Intel[®] 5100 Memory Controller Hub Chipset

Specification Update

Revision 008US

41. Incorrect CKE behavior during recovery from S3 suspend

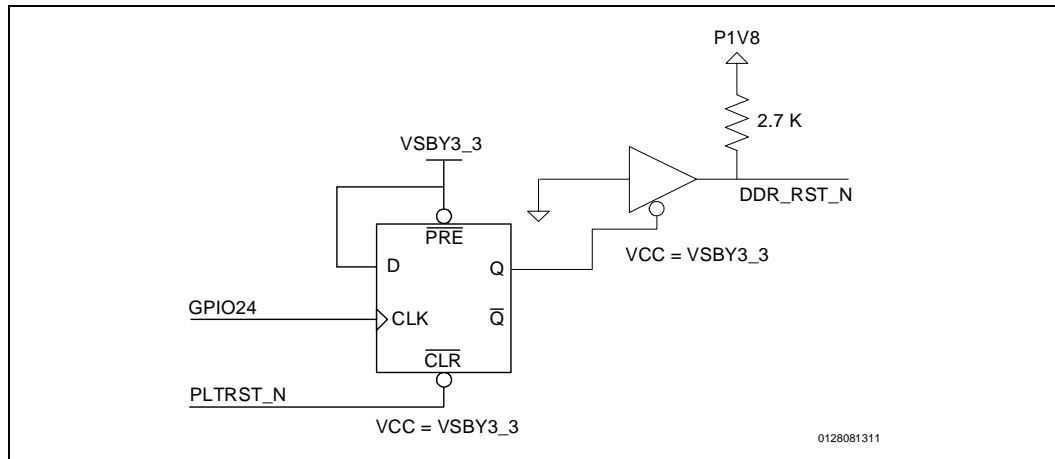
Problem: During the initial stage of exit from System Sleep State “S3” (suspend to RAM), the CKE signal is driven to an indeterminate state (High, Low, or tristate).

Workaround: The workaround requires both a board-level circuit and a BIOS change. The workaround holds the DIMMs in reset using a flipflop clocked by a GPIO from the ICH9R under control of the BIOS. An output controlled buffer is also required to transition the 3.3 V output of the flipflop to the 1.8 V reset input of the DIMM (see diagram below). The possible GPIOs are GPIO[28,27,24,12]. The GPIO implemented in the circuit is incorporated into the BIOS as a build option by an Intel BIOS Vendor (IBV).
